## SERVICE BULLETIN AMATEUR RADIO

SUBJECT	DATE
TS-950SD N.B. GATE SWITCHING NOISE	01/11/90

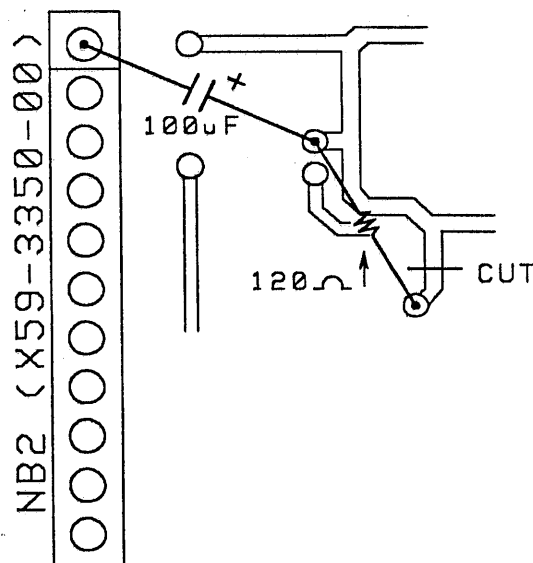
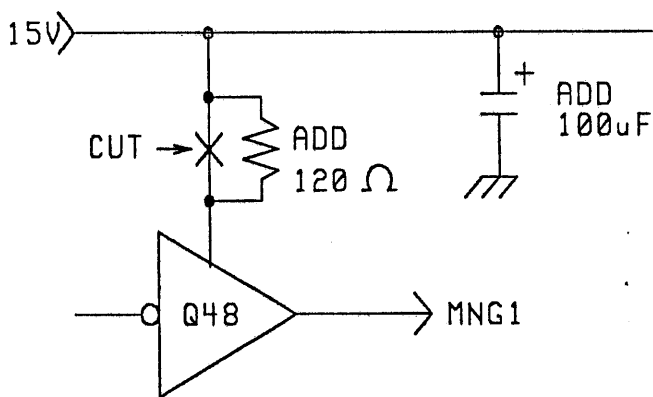
Switching noise from the main band noise blanker circuit may be induced on the 15V line and pass through the AF amplifier to the speaker. The following modification will correct this condition.

1. Cut the foil as shown in the accompanying diagram.
2. Add a 120 ohm resistor between the emitter of Q48 and the 15V line.
3. Add a 100uF, 16V capacitor between the 15V line and ground.
4. Reassemble the transceiver.
